Village of Mukwonago
SPECIAL VILLAGE BOARD MEETING
Notice of Meeting and Agenda
Monday, August 1, 2016

Change Order

Project: CTH NN	Owner: Waukesha County	Owner's Contract No.: 14-2819(4)
Contract: CTH NN, CTH ES to STH 83		Date of Contract: 6/20/2016
Contractor: Musson Bros., Inc.		Engineer's Project No.: 1164802

RE: Change/Relocation/Removal and or Installation of Street Lighting located at CTH NN, from Clarendon St to CTH ES
 We Energies Work Request Number 3919538

SHEET 10

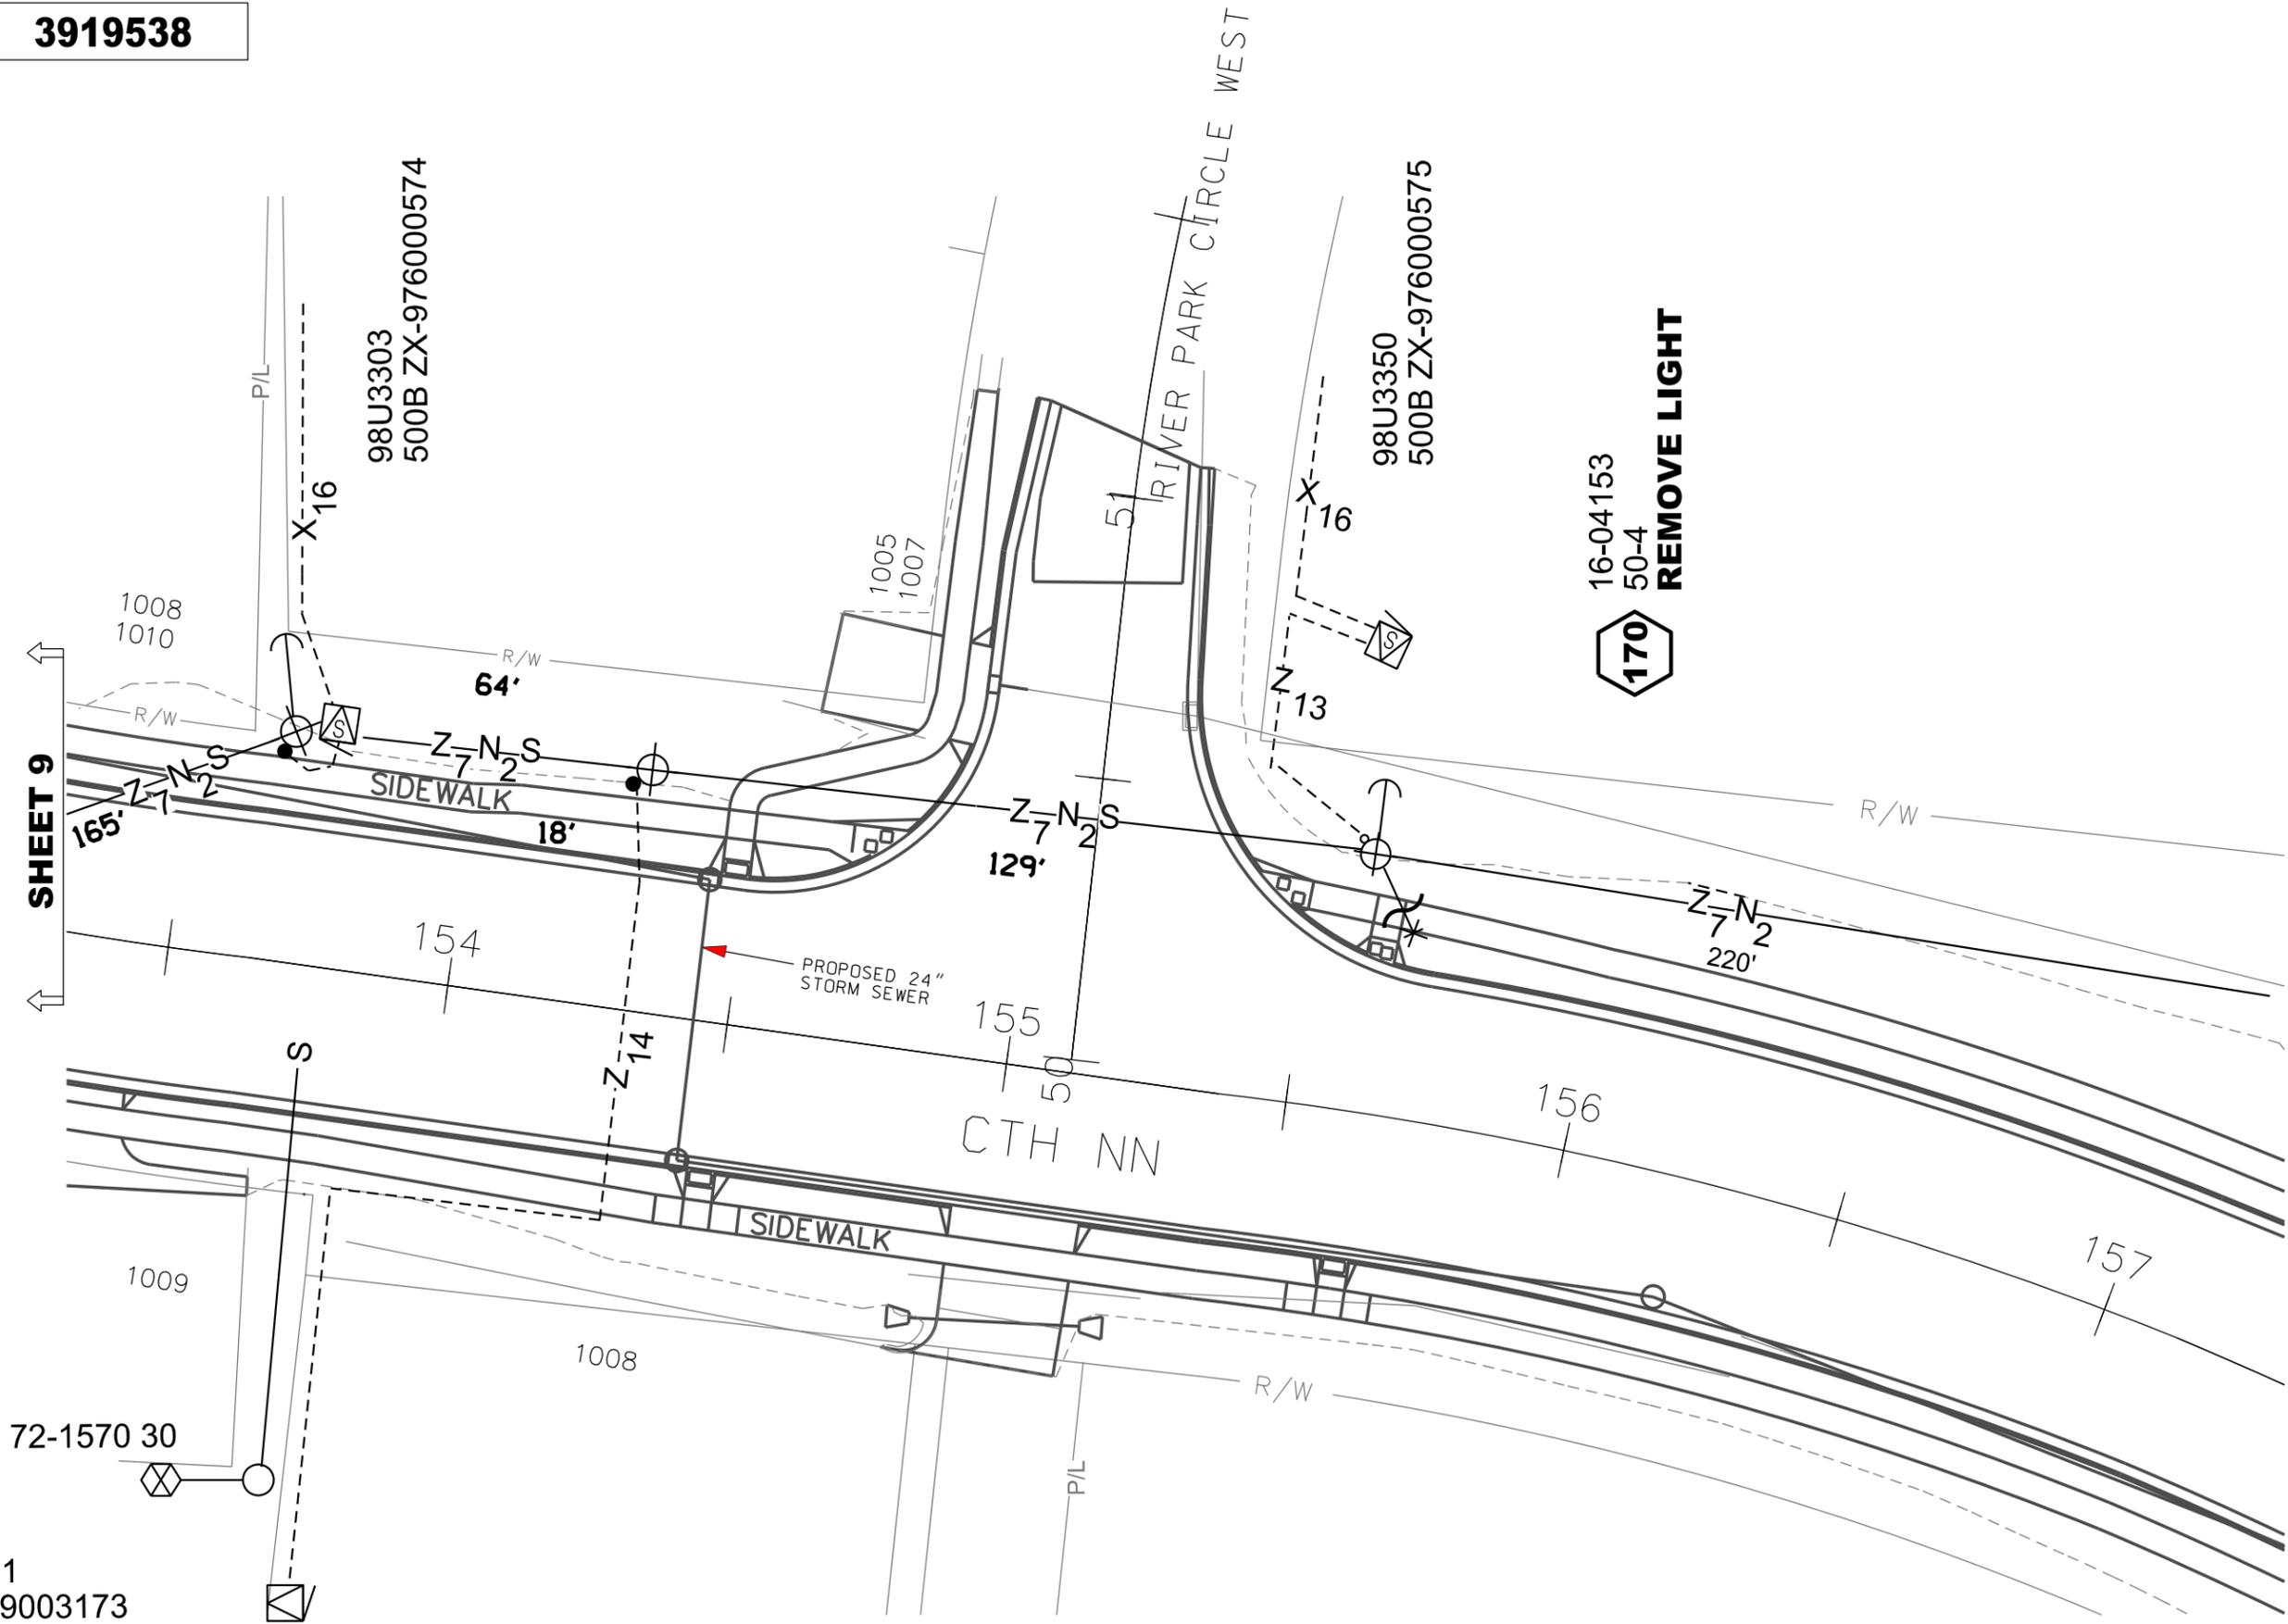
16-04153
50-4
REMOVE LIGHT
